RIGHT OF WAY PLAN OF THE HOLBROOK - SPRINGERVILLE STATE HIGHWAY

PROJECT NO. F-051-1-809

APACHE COUNTY

HOLBROOK — SPRINGERVILLE HWY.
BEAVER DAM WASH — HUNT SECTION
APACHE COUNTY

PROJECT NO.	F-051-1-809
DRAWING NO.	D-1-T-241
SHEET NO.	6 of 23
DRAWN BY	E.B.S.
DATE COMP.	8-29-69
SCALE	1" = 100'
CONSULTANT	GREER ENGR. CO.

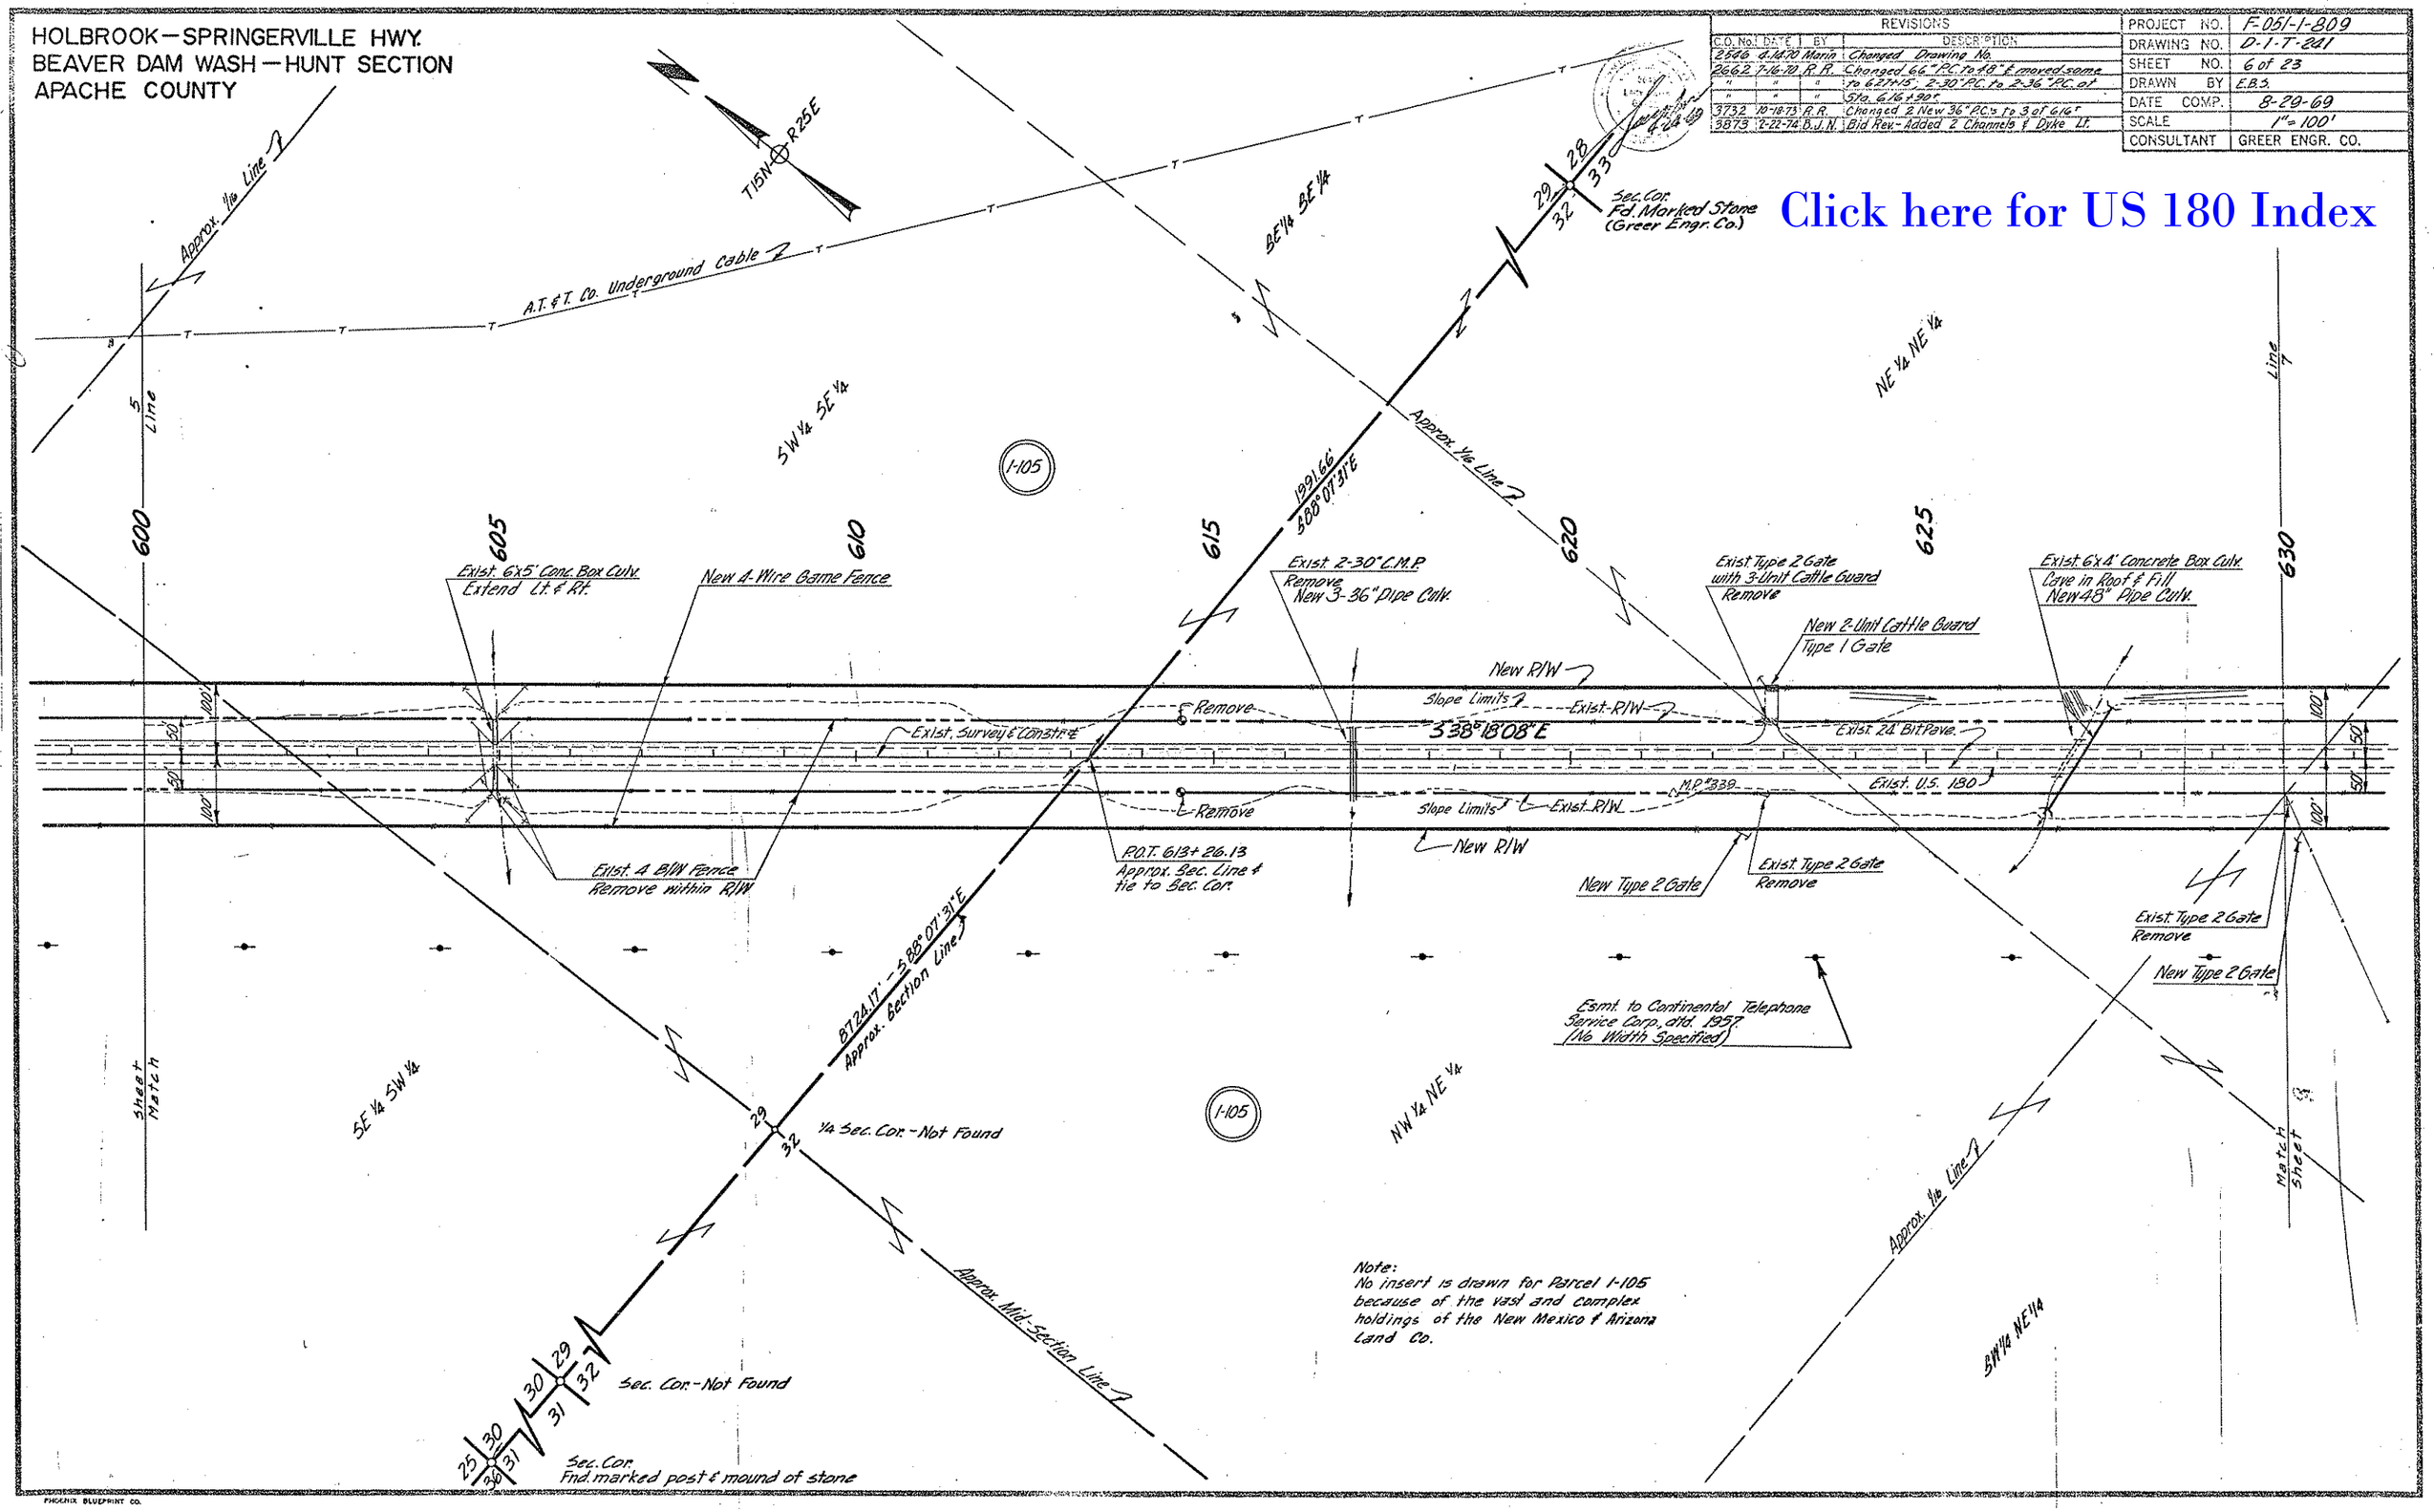
REVISIONS			
C.O. No.	DATE	BY	DESCRIPTION
2846	4-14-70	Morris	Changed Drawing No.
2662	7-16-70	R.R.	Changed 66" P.C. to 48" & moved some
"	"	"	to 627+45, 2-30" P.C. to 2-36" P.C. at
"	"	"	Sta. 616+90±
3732	10-18-73	R.R.	Changed 2 New 36" P.C.'s to 3 of 66"
3873	12-22-74	D.J.N.	Bid Rev.-Added 2 Channels & Dike Lt.

PROJECT NO.	F-051-1-809
DRAWING NO.	D-1-T-241
SHEET NO.	7 of 23
DRAWN BY	E.B.S.
DATE COMP.	8-29-69
SCALE	1"=100'
CONSULTANT	GREER ENGR. CO.

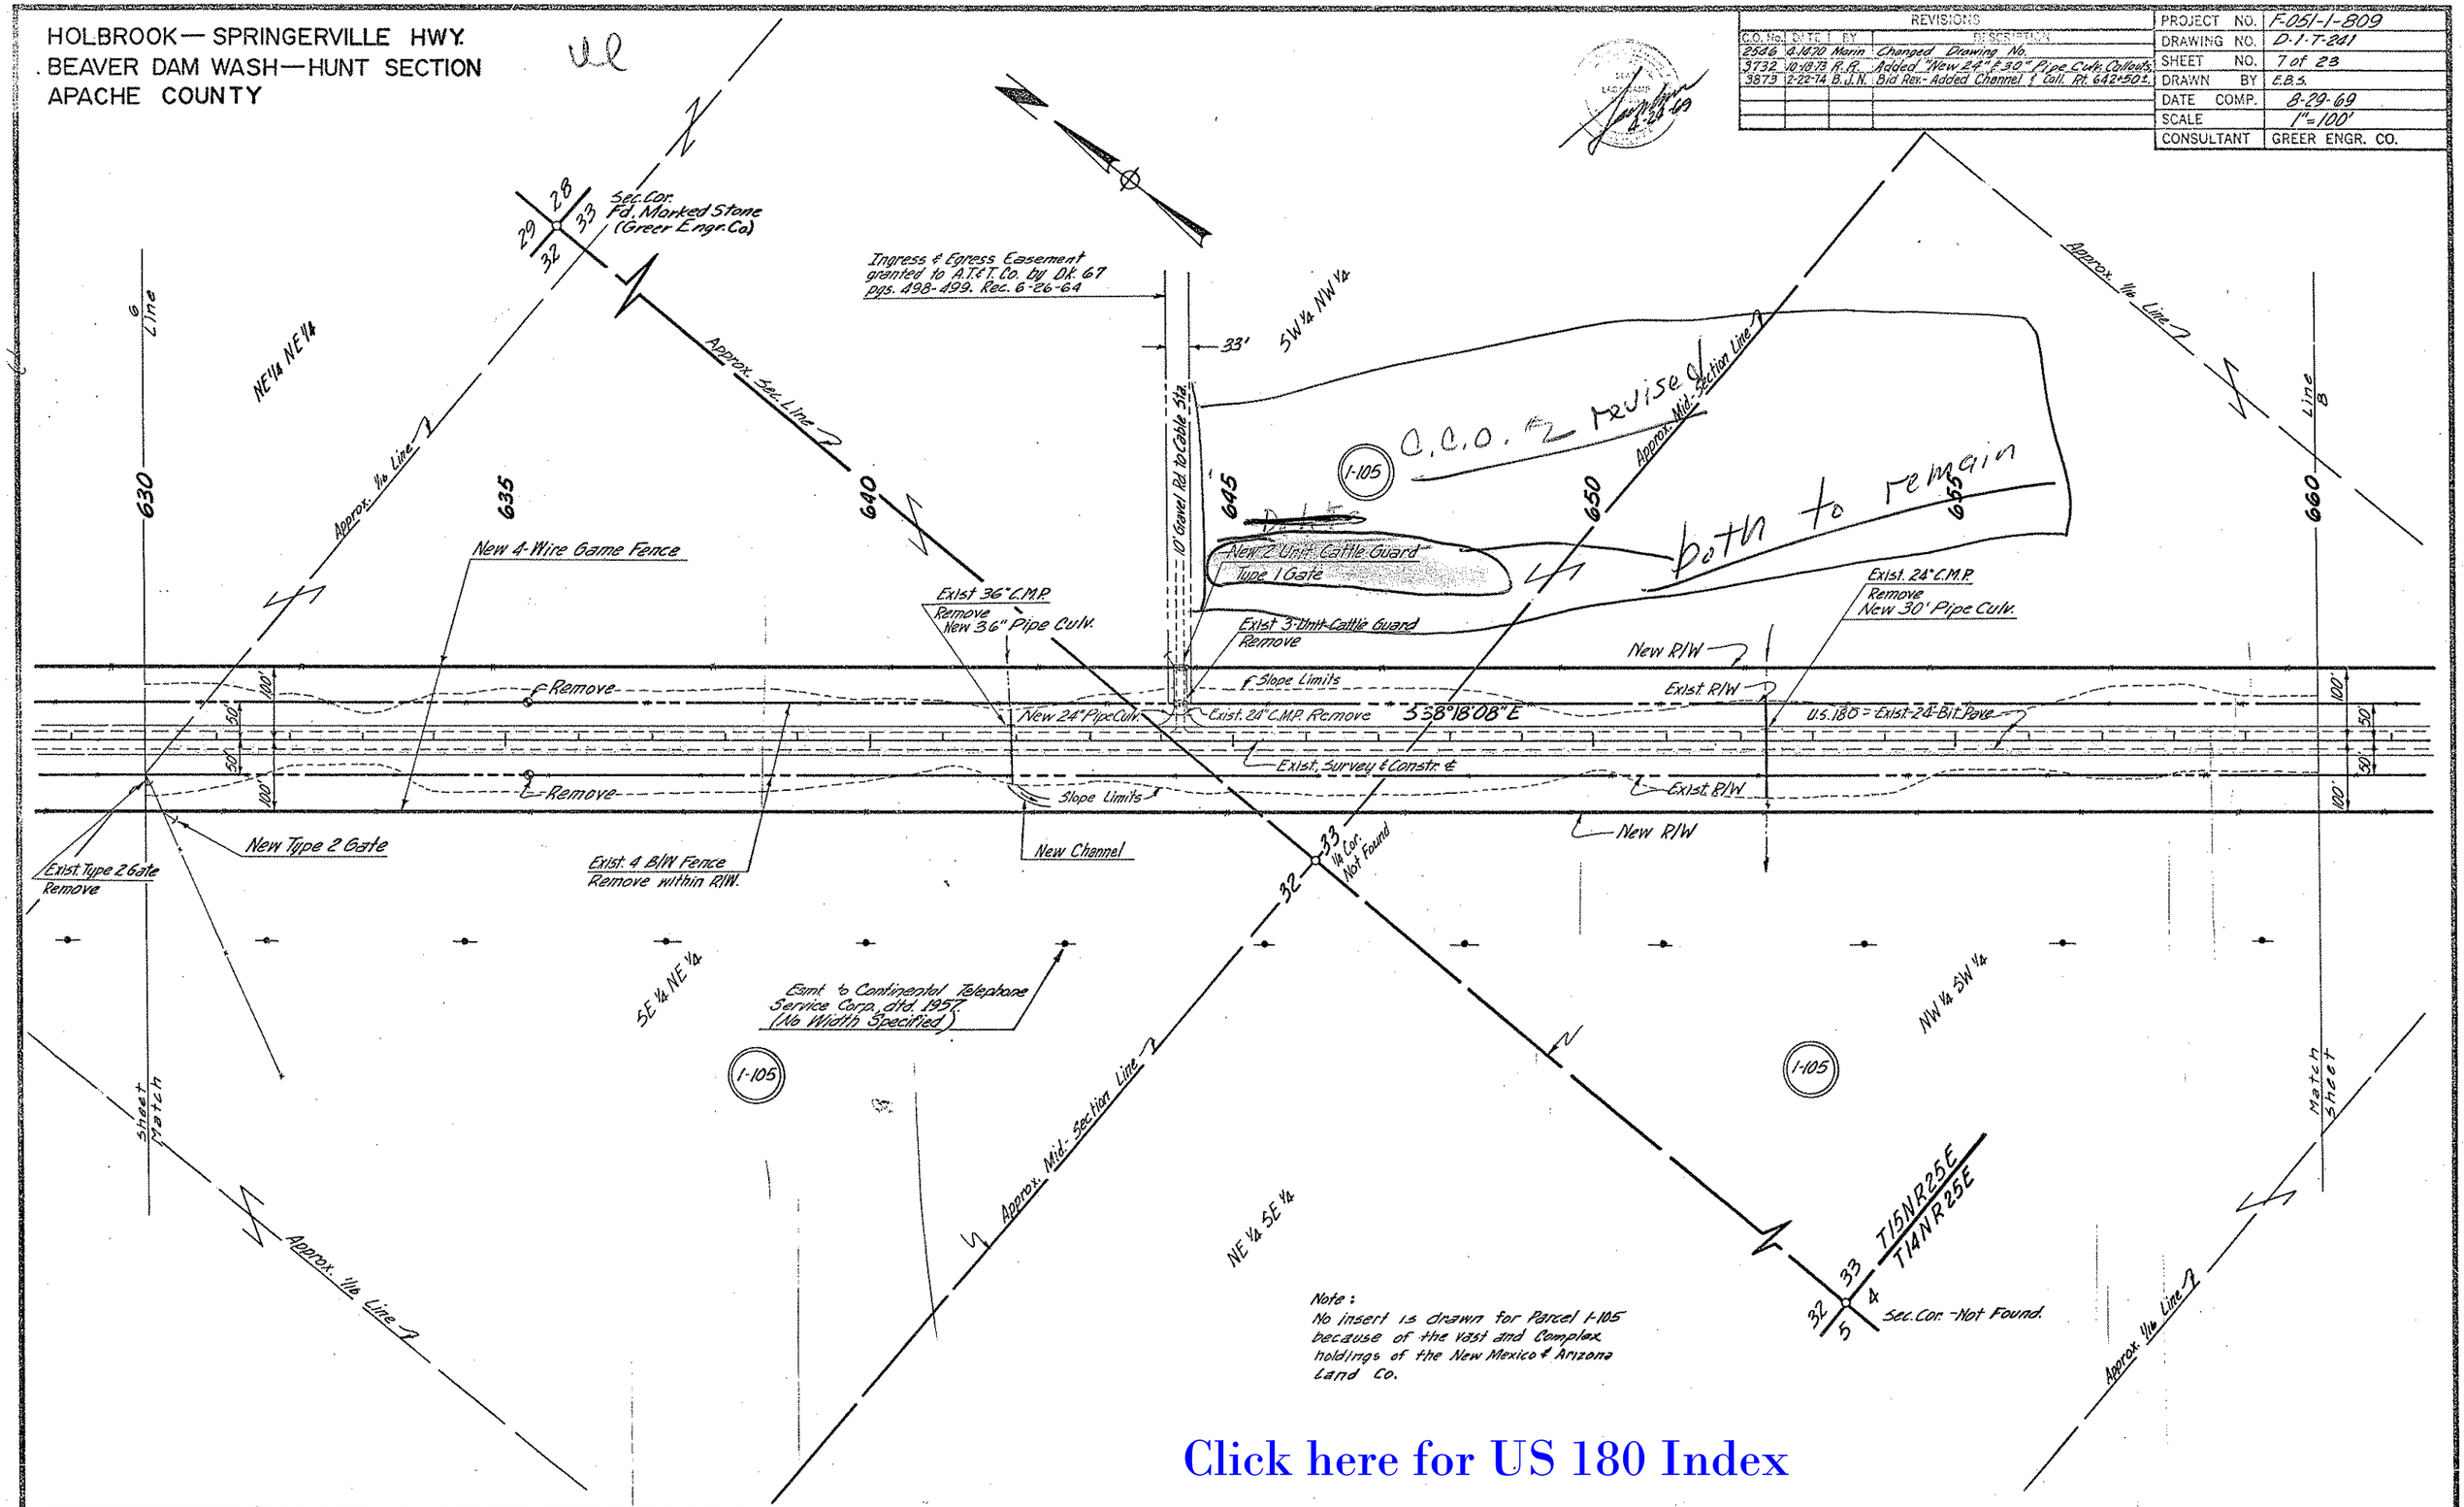
REVISIONS				
C.O. No.	DATE	BY	DESCRIPTION	
2546	4-14-70	Marin	Changed Drawing No.	
3732	10-18-73	R.R.	Added "New 24" & 30" Pipe Culv. Callouts"	
3873	2-22-74	B.J.N.	Bid Rev.- Added Channel & Coll. Rt. 642+50±.

PROJECT NO.	F-051-1-809
DRAWING NO.	D-1-T-241
SHEET NO.	8 of 28
DRAWN BY	E.B.S.
DATE COMP.	8-29-69
SCALE	1" = 100'
CONSULTANT	GREER ENGR. CO.

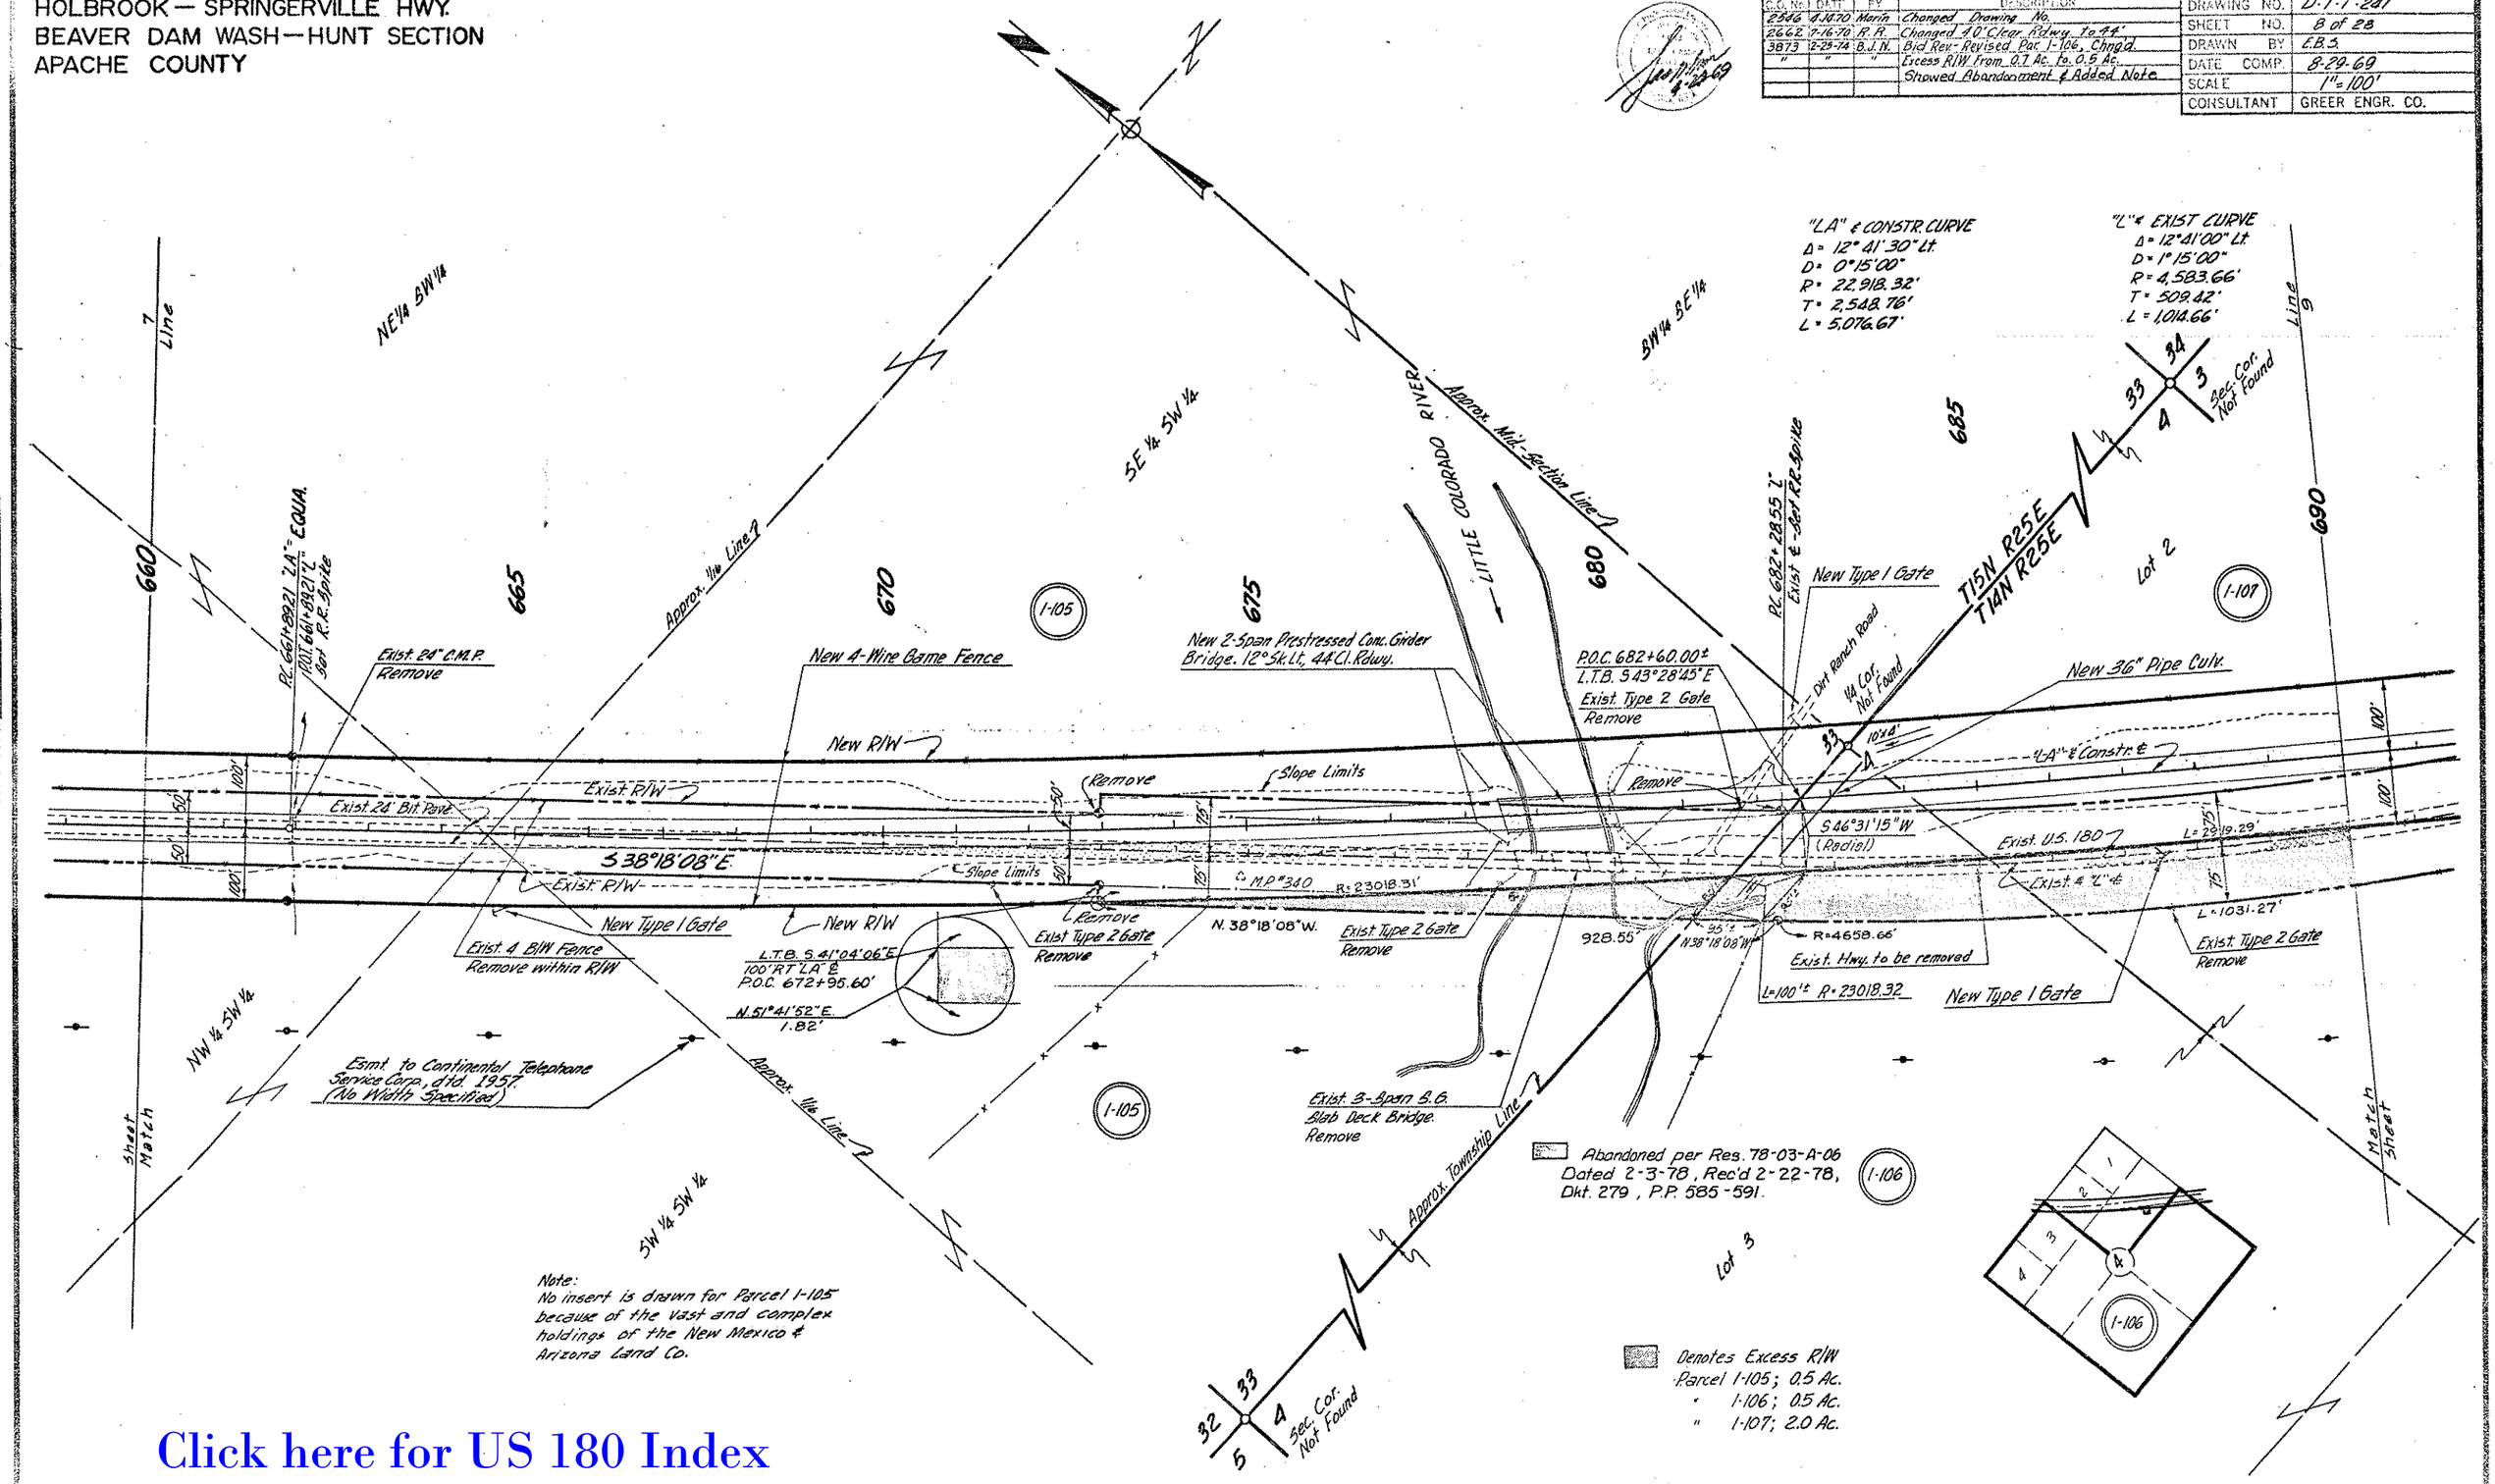
REVISIONS			
C.O. No.	DATE	BY	DESCRIPTION
2546	4-10-70	Marin	Changed Drawing No.
2662	7-16-70	R.R.	Changed 40' Clear Rdwy. to 44'
3873	12-29-74	B.J.N.	Bid Rev - Revised Par 1-106, Chngd.
"	"	"	Excess R/W from 0.7 Ac. to 0.5 Ac.
			Showed Abandonment & Added Note
